ADDRESS: 1304 SPRUCE ST

Proposal: Replace front entry door

Review Requested: Final Approval

District Designation: Washington Square West Historic District, Contributing, 9/13/2024

Requested replacement door #1

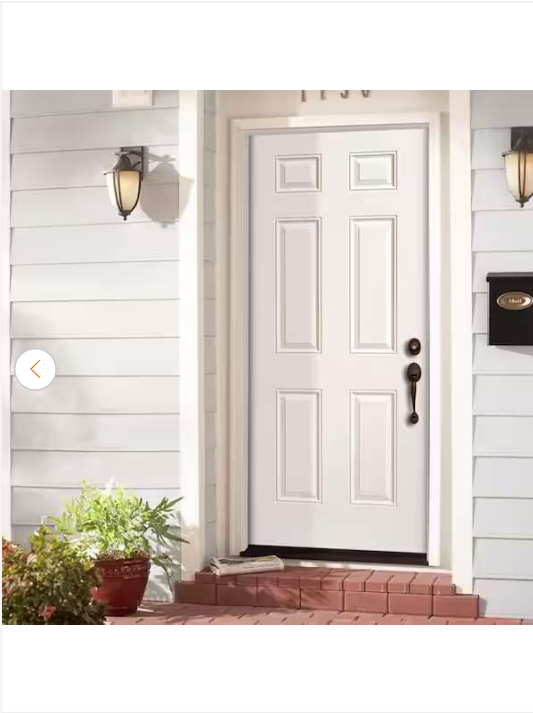
- *Standard 6: Deteriorated historic features will be repaired rather than replaced. Where the severity of deterioration requires replacement of a distinctive feature, the new feature will match the old in design, color, texture and, where possible, materials. Replacement of missing features will be substantiated by documentary and physical evidence.*
 - The proposed steel or wood six-panel doors do not match the old in design, texture, or materials in the case of the steel option.

STAFF RECOMMENDATION: The staff recommends denial of the proposed door replacement, but approval of a door that closely approximates the detailing of the historic door, pursuant to Standard 6.
